HISTORIC AND DESIGN REVIEW COMMISSION

June 05, 2024

HDRC CASE NO: 2024-155
ADDRESS: 2100 BROADWAY
LEGAL DESCRIPTION: NCB 1763 BLK 33 LOT 1-4, 7-12, P-100-103 & P-105 -106 (PORTION OF CLOSED ALLEY)1
ZONING: IDZ, RIO-1, NCD-9
CITY COUNCIL DIST.: 2
APPLICANT: Ariel Vega/PDI
OWNER: 4M BROADWAY LLC
TYPE OF WORK: Construction of commercial structures and a sub-grade parking structure
APPLICATION RECEIVED: April 12, 2024
60-DAY REVIEW: June 11, 2024
CASE MANAGER: Edward Hall

The applicant is requesting conceptual approval to construct a multi-component restaurant development on the vacant lot at 2100 Broadway, located within RIO-1. The proposed construction will feature a restaurant structure, a dining courtyard, a pit house and a sub-grade parking structure with a vertical circulation component at the corner of Broadway and Alling.

SITE PLAN
N.T.S.

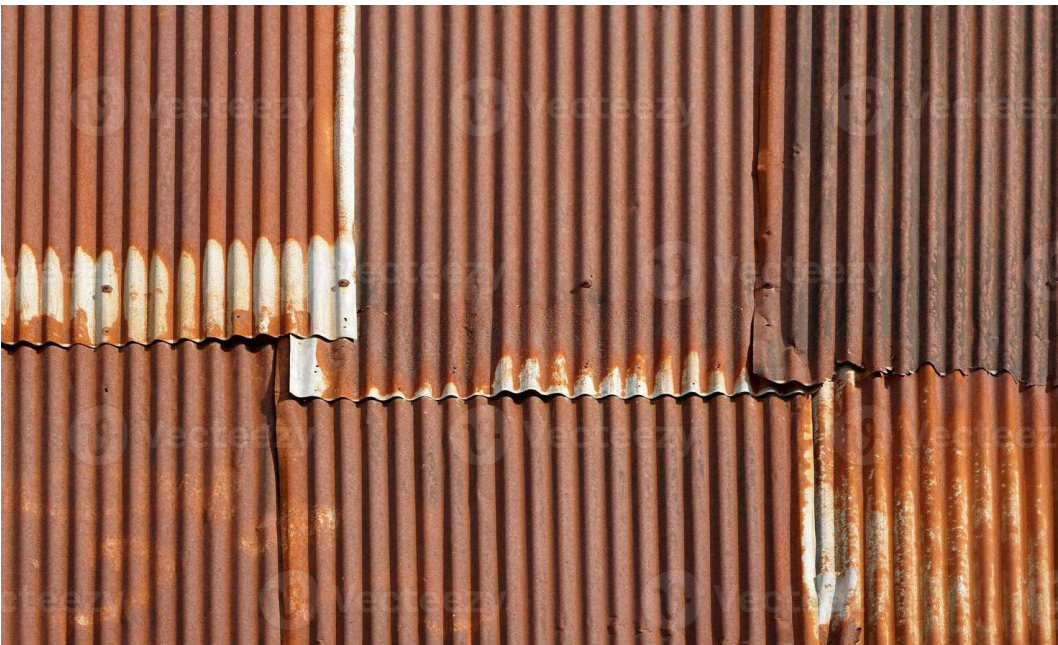
- e. **PEDESTRIAN CIRCULATION** – Per the UDC Section 35-672(a) in regards to pedestrian circulation, an applicant shall provide pedestrian access among properties to integrate neighborhoods. The applicant has proposed sidewalks parallel to the public right of way on Broadway and Alling. Additionally, the applicant has

LG: Questions regarding curb cuts, sub-grade parking and if parking will be provided for the public.

MC: Ramp would serve a garage for restaurant and (future) hotel parking. Predominantly for restaurant parking.

Corrugated
Corten Steel

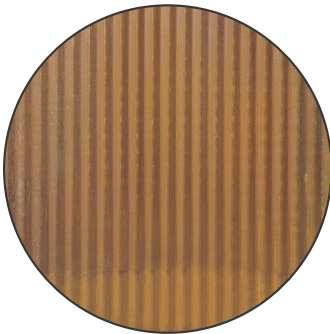
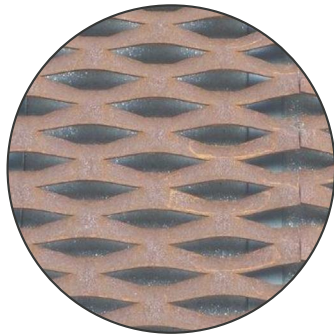
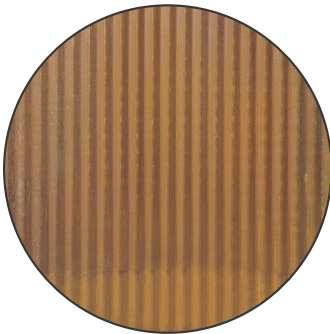
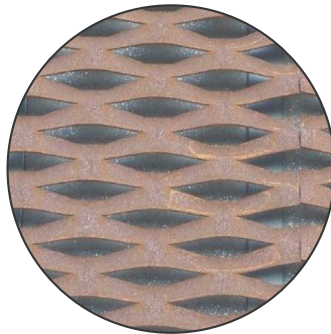
- p. ARCHITECTURAL FOCAL POINT – The UDC Section 35-672(c)(1), notes that an architectural focal point is to be incorporated into the design when a property is situated in such a manner as to appear as the terminus at the end of the street. An architectural feature will be considered to be a focal point through any of the following methods, but not limited to: additional height, creation of a tower, variation in roof shape, change of color or materials or the addition of a design enhancement feature. At the corner of Broadway and Alling, the applicant has proposed to construct a pedestrian circulation element to feature corten steel siding, a corrugated metal roof, and corten mesh screening.

JV: Questions about materials, specifically metal materials. Finds rusted corten to be too harsh for context with other materials. Find inspiration from existing buildings.
